A FLECK PERFORMANCE BULLETIN

October 12, 1995

5600 Powerhead & 3200 Timer Modifications

5600 Powerhead

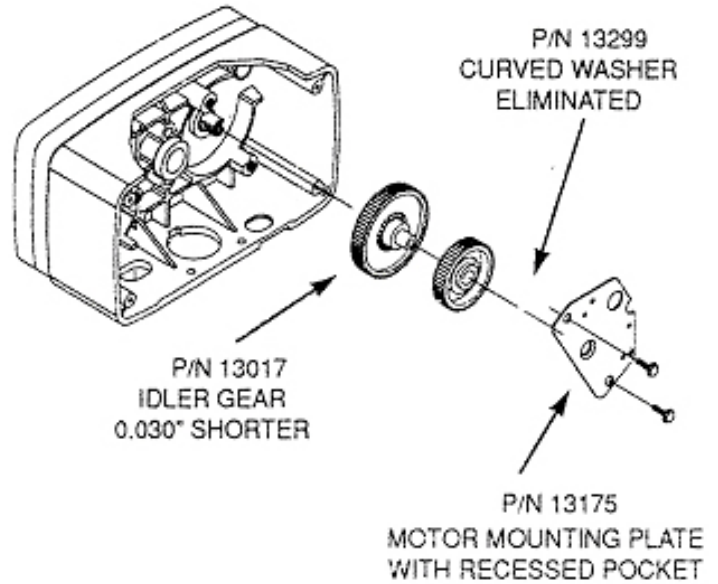
We will be making an improvement to the 5600 powerhead and the 3200 timer. This change will eliminate the need for the P/N 13299 curved washer between the motor mounting plate and the drive gear. This change was made by modifications to the motor mounting plate and idler gear. The motor mounting plate now will have a recessed pocket stamped on it, and the idler gear is 0.030" shorter. The drawings on the following page indicate these modifications.

Note: P/N 60369-02 contains the necessary items to convert a 5600 powerhead from old style to new style.
